17075-18

RE: Re: Transmittal of Response to U.S. EPA Comments on the Phase 1B RFI Work Plan  
Amendment, Saginaw Metal Casting Operations, U.S. EPA ID No MID 041-793-340

## Response to U.S. EPA Electronic Comments on GM's Phase 1B RFI Work Plan Amendment

**Response:**

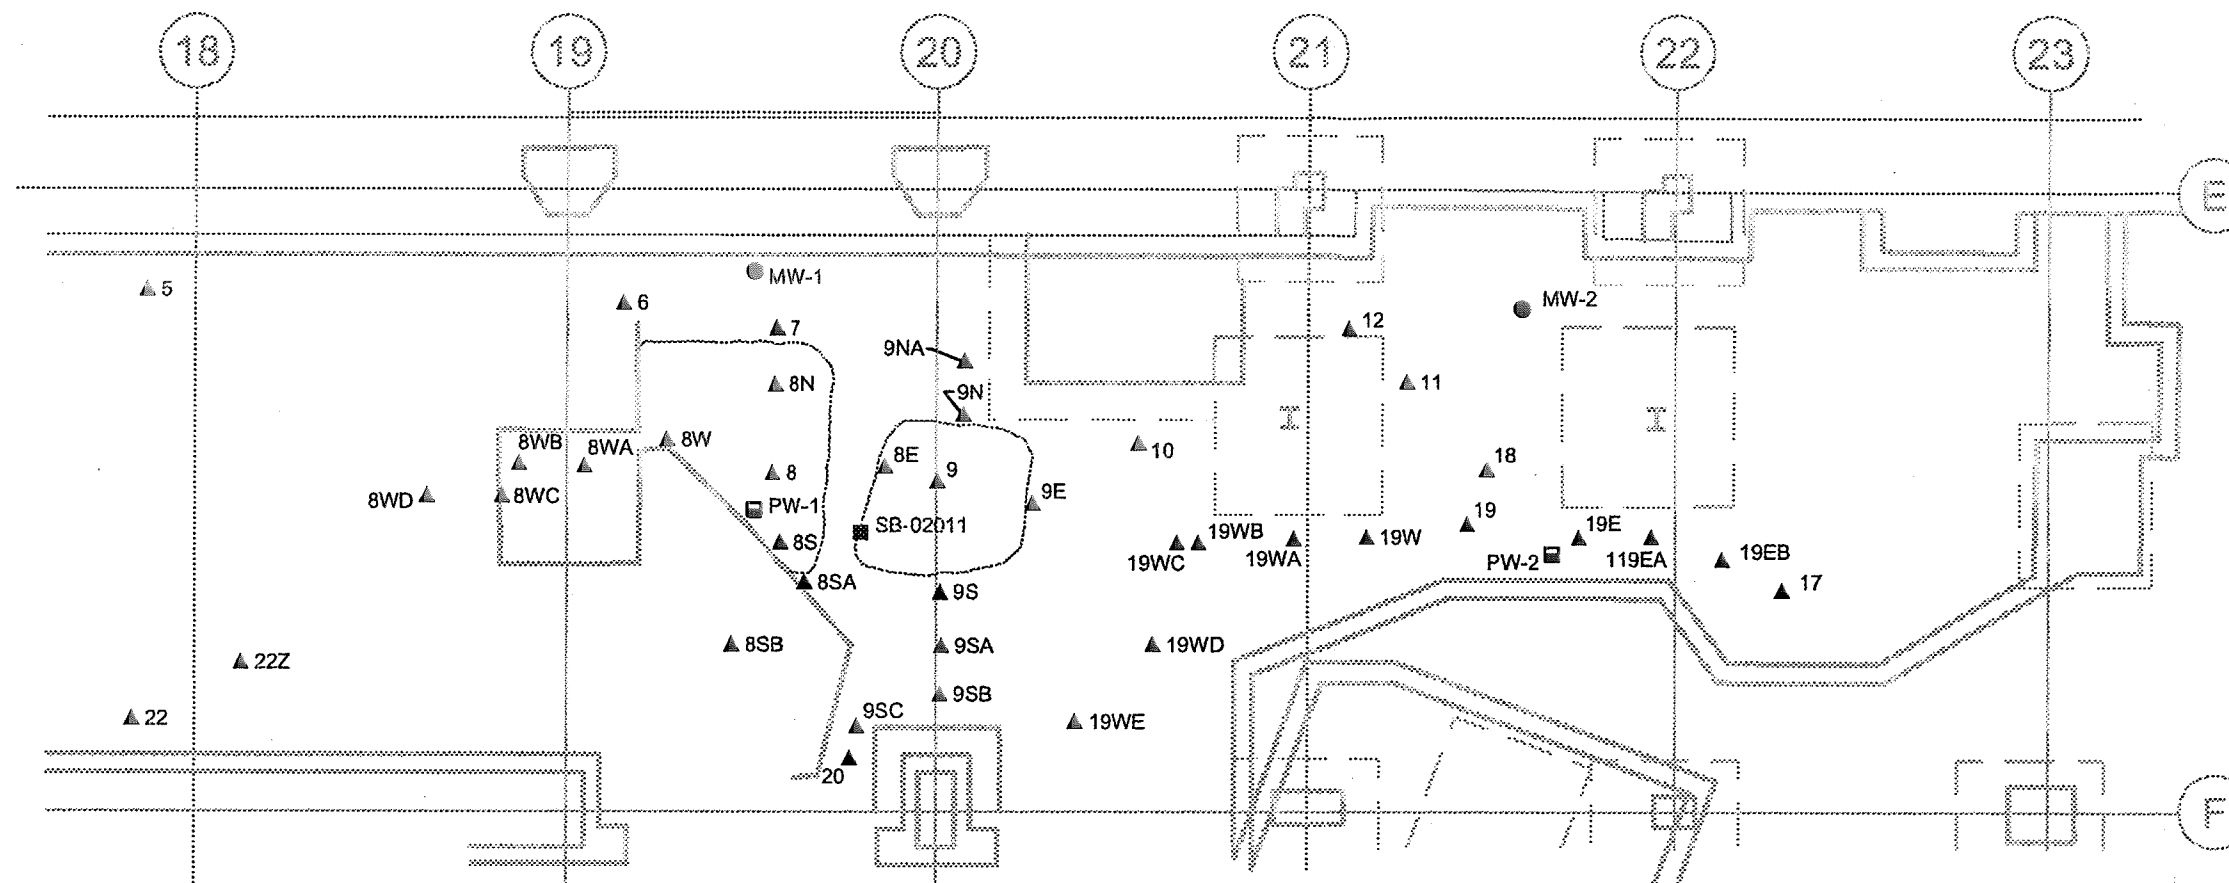
**b) Soil characterization for lead appears warranted due to SLE for lead at SB-00508.**

*Numerous soil samples have been collected within the northern portion of Investigative Unit B (March 9, 2000, Monthly Progress Report and February 8, 2001, Monthly Progress Report). Sample results for total lead are tabled below (refer to the attached Figure for IU B for sample locations). These samples which have been submitted to the U.S. EPA show that the Phase 1B Screening Level exceedances of lead in soil in this area have been sufficiently defined. However, lead will be added to the analyte list for soil samples collected from the proposed borings located to the east of SB-00508.*

figure --  
#8 MOLD LINE (D.28)  
GENERAL MOTORS CORPORATION  
SAGINAW METAL CASTING OPERATIONS  
*Saginaw, Michigan*

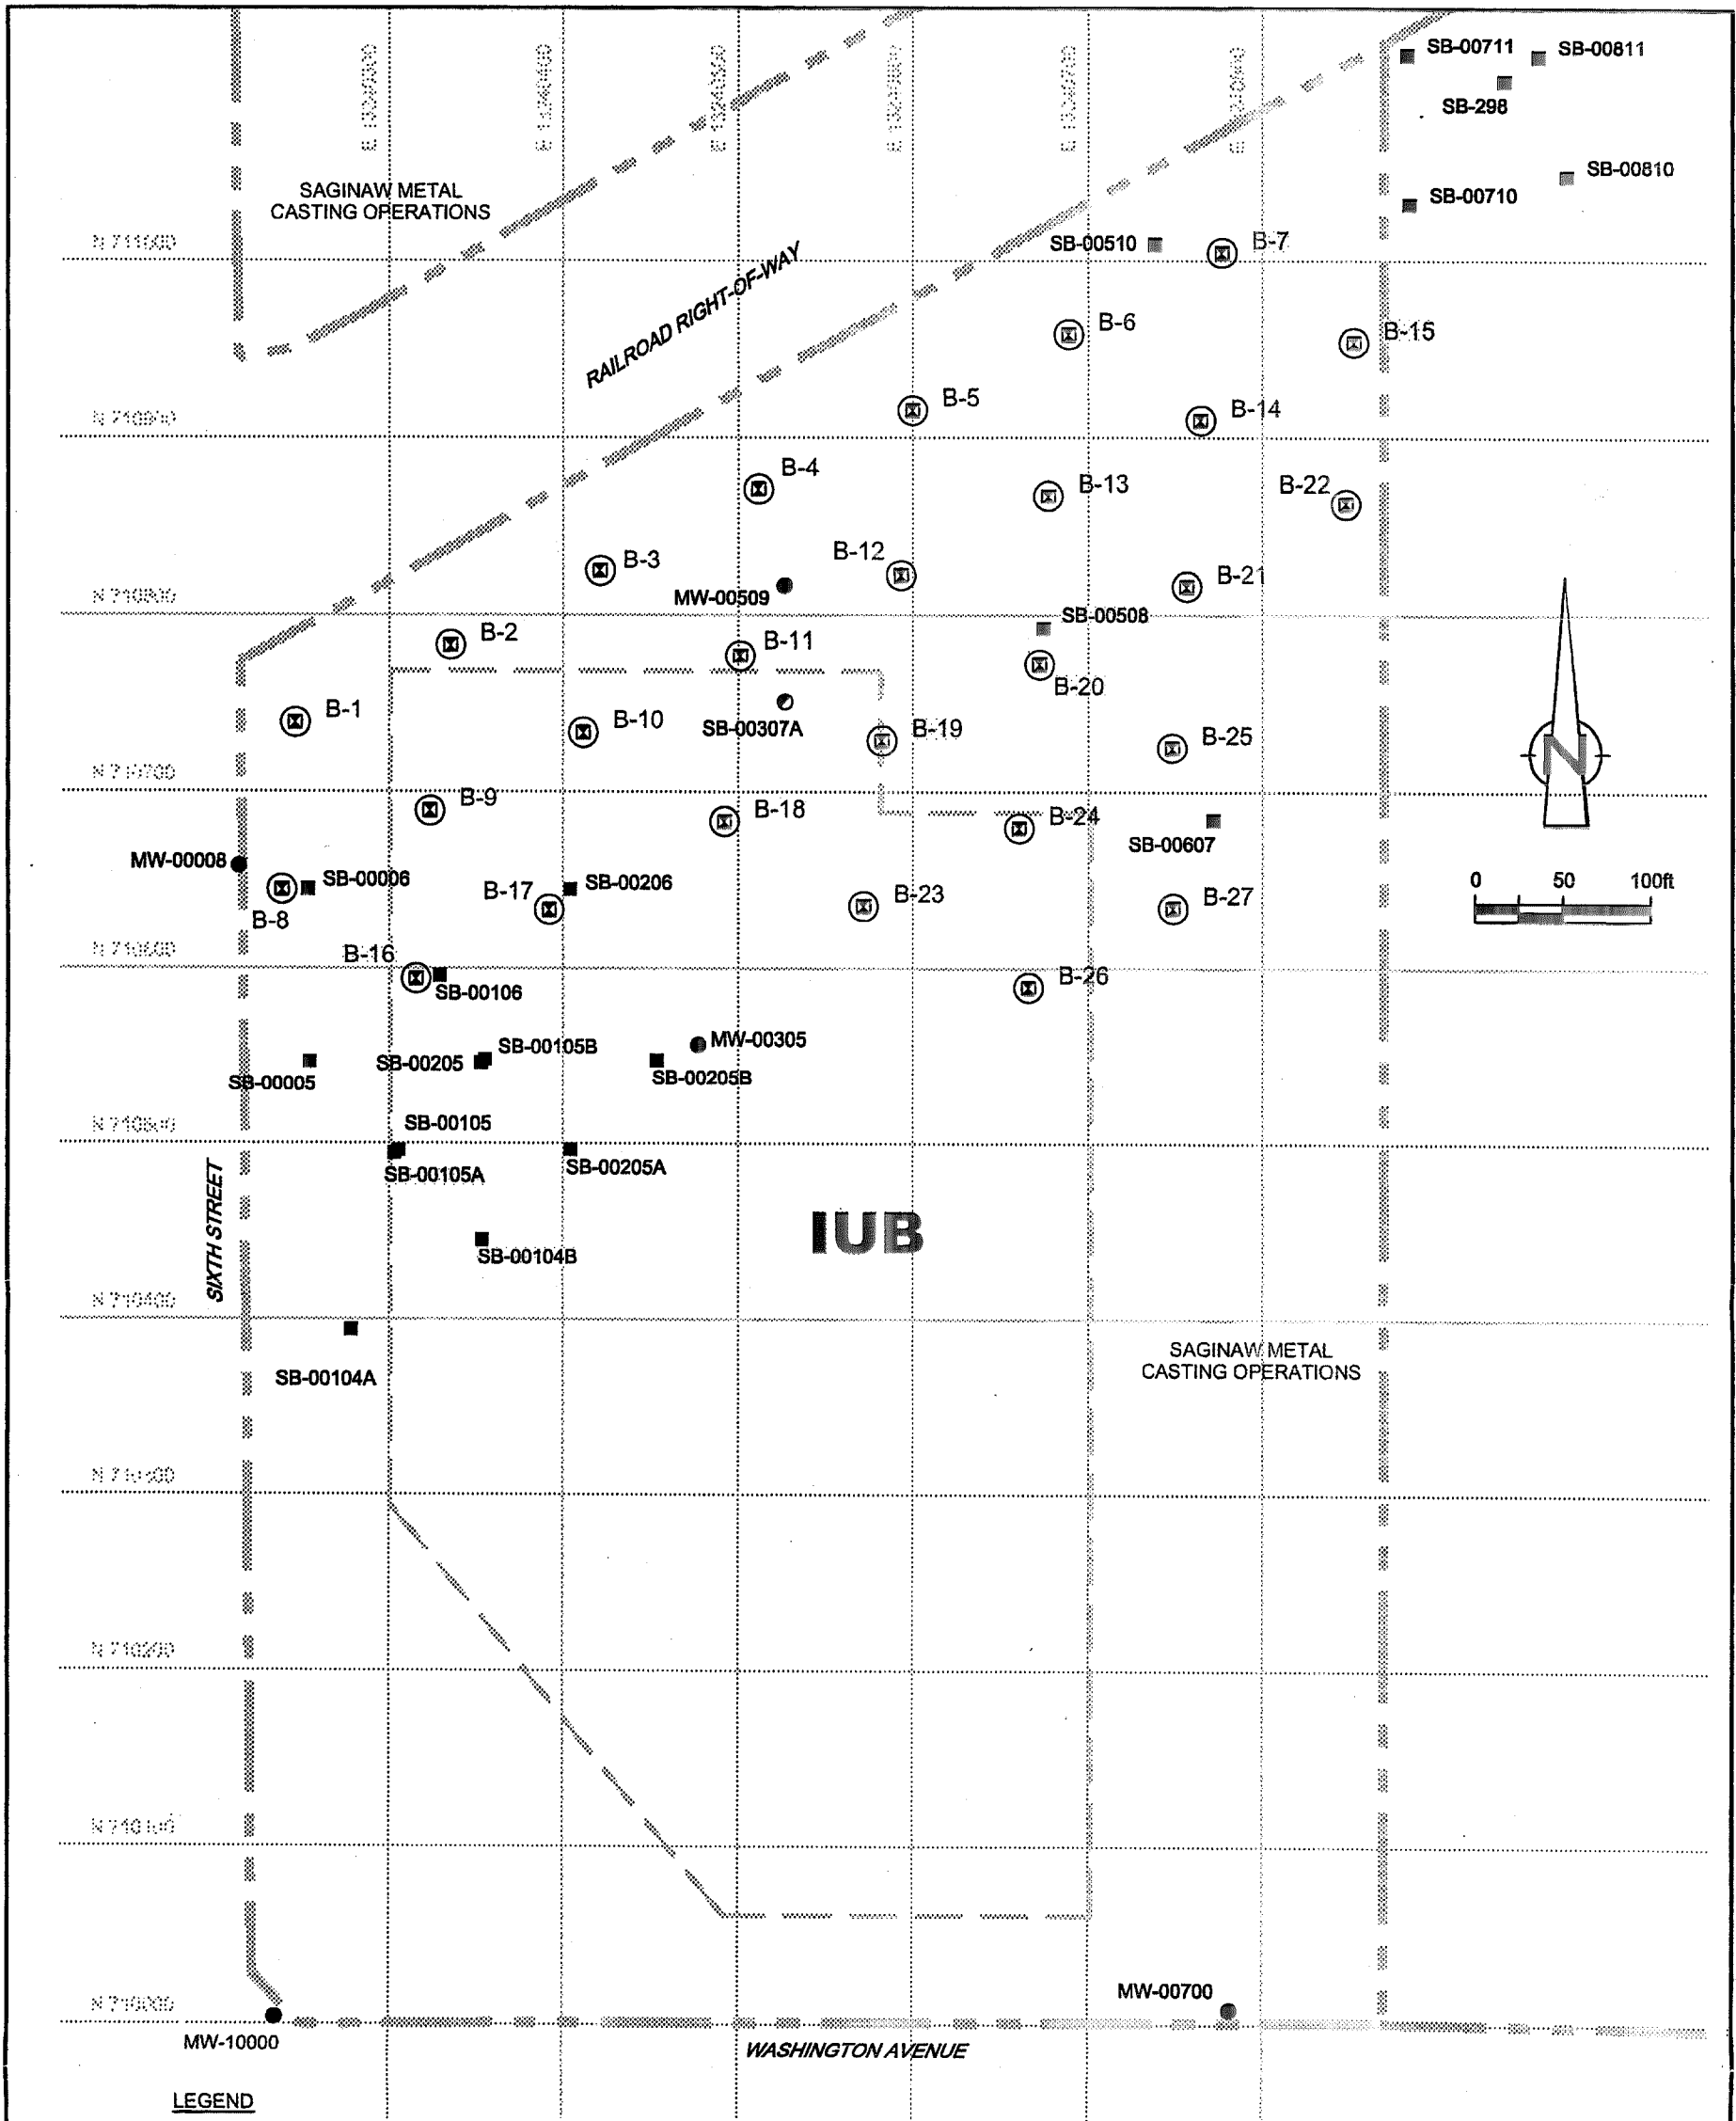
**2. The depth of the Phase 1B samples from the #8 Mold Line area must be compared to the depth of the samples previously taken by RMT. Monitor wells had been proposed for this area, an explanation of why they were not installed is needed.**

**4. The relationship of the historical sample locations to these sample locations for the #8 Mold Line and the Rail Road by the Cupola Tower area need to be shown. This could be accomplished by providing both sets of samples on a single map.**

*The Phase 1A RCRA Facility Investigation (RFI) Report and Phase 1B RFI Work Plan (April 19, 2000) presented the historical PCB concentrations (Table 5-11) collected by RMT at the #8 Mold Line Basement PCB Contamination (AOI D.28). Five additional soil borings were completed as part of the Phase 1B RFI. During each investigation, samples were identified as depths from the drilling surface (e.g., basement floor, first floor, etc.). Table 5-11 is reproduced below with the Phase 1B data appended. Sample elevations (ft. MSL) have been added for all data points in Table 5-11. In addition, a Figure showing all sample locations is provided (attached).*

*One monitoring well was proposed to be installed during the Phase 1B RFI (at location SB-02011), if groundwater was encountered. Groundwater was not encountered at any of the Phase 1B soil borings in this area, therefore, a groundwater monitoring well was not installed.*

*See response to Comments 2 and 3, and attached figures for AOI D.28 and D.32, respectively.*
